**Re: Western Sydney Aerotropolis Draft Precinct Plans**

# **SUBMISSION TO THE EXHIBITION OF THE DRAFT AEROTROPOLIS PRECINCT PLAN**

**Prepared for  
The University of Sydney**

Figure 1: University Land

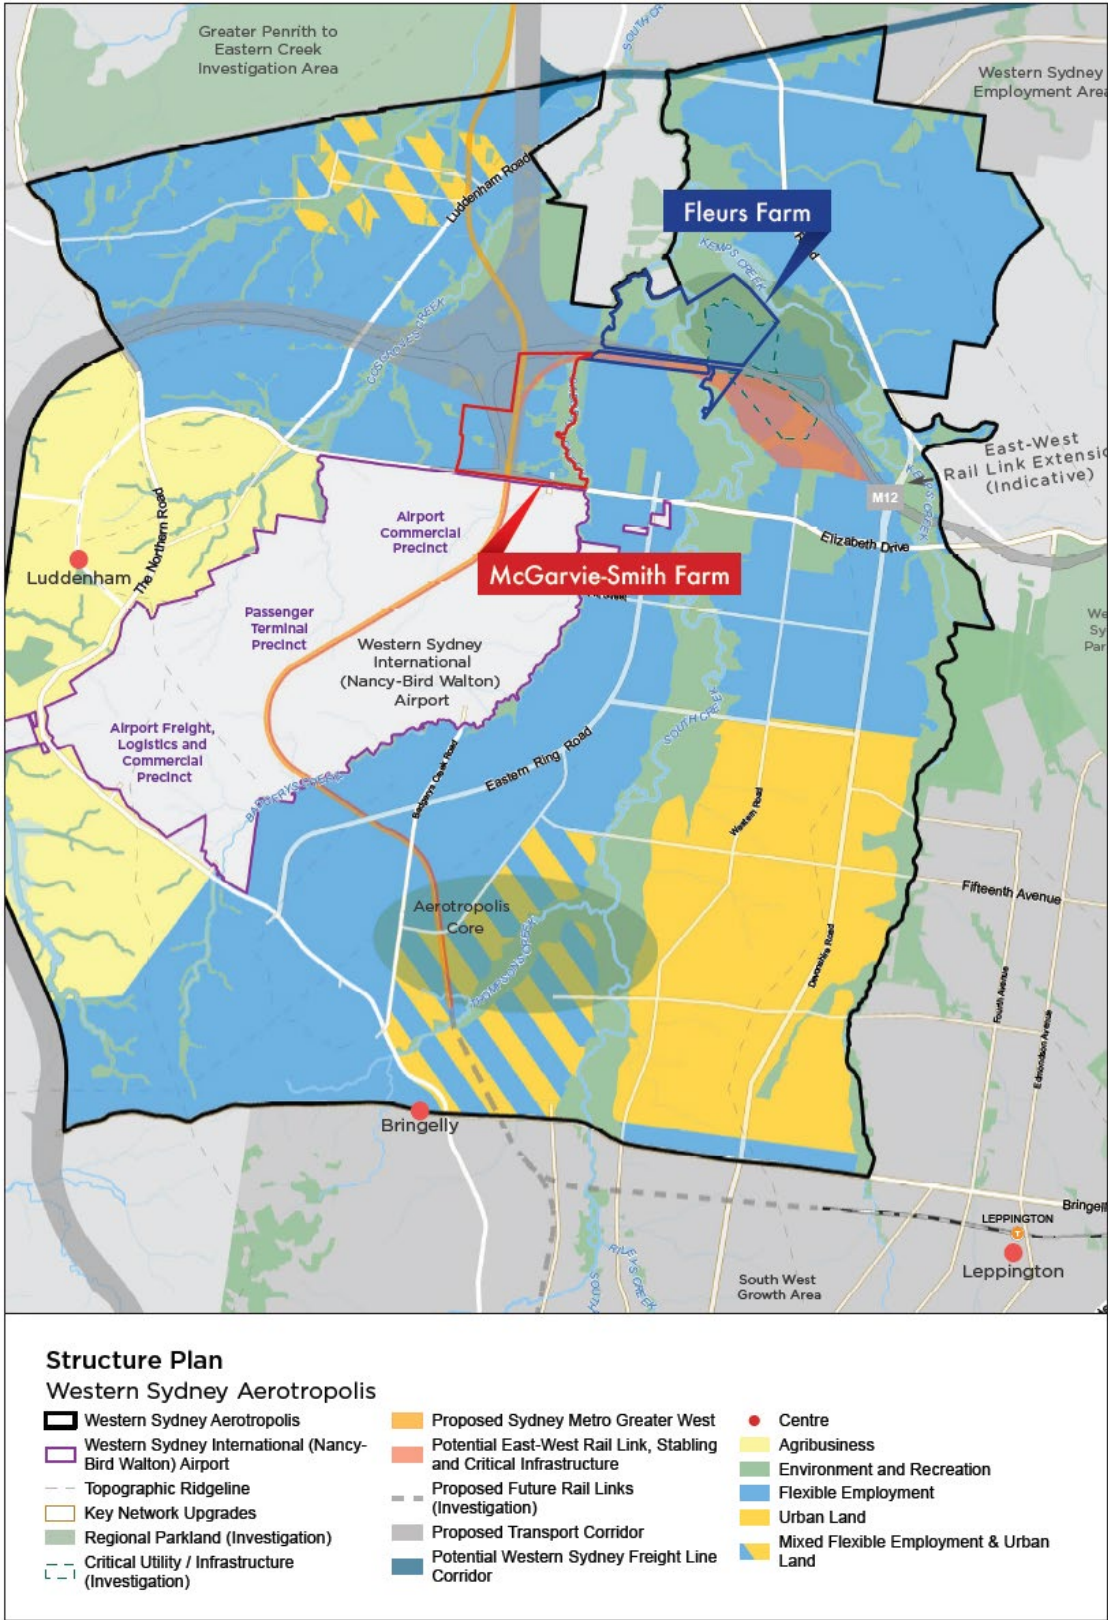
As indicated on **Figure 1**, Fleurs West is part of the University land located in the Badgerys Creek Precinct. Land above the 1 in 100 year flood level is within the Enterprise Zone under the SEPP WSA. The DAPP indicates Fleurs West north of the M12 corridor as being

conservation area (S3.2.7 and Figure 15 of DAPP). This land has no biodiversity value as indicated in S3.2.8 and Figure 16 of DAPP.

There is no basis for the designation of this land as conservation provided in the technical studies and no discussion of the need for, or reasons behind, this area being designated for conservation or open space. There is no commitment for this land to be acquired for conservation purposes.

This area must be indicated for enterprise use consistent with its zoning and reflected as such on a Precinct Plan figures.
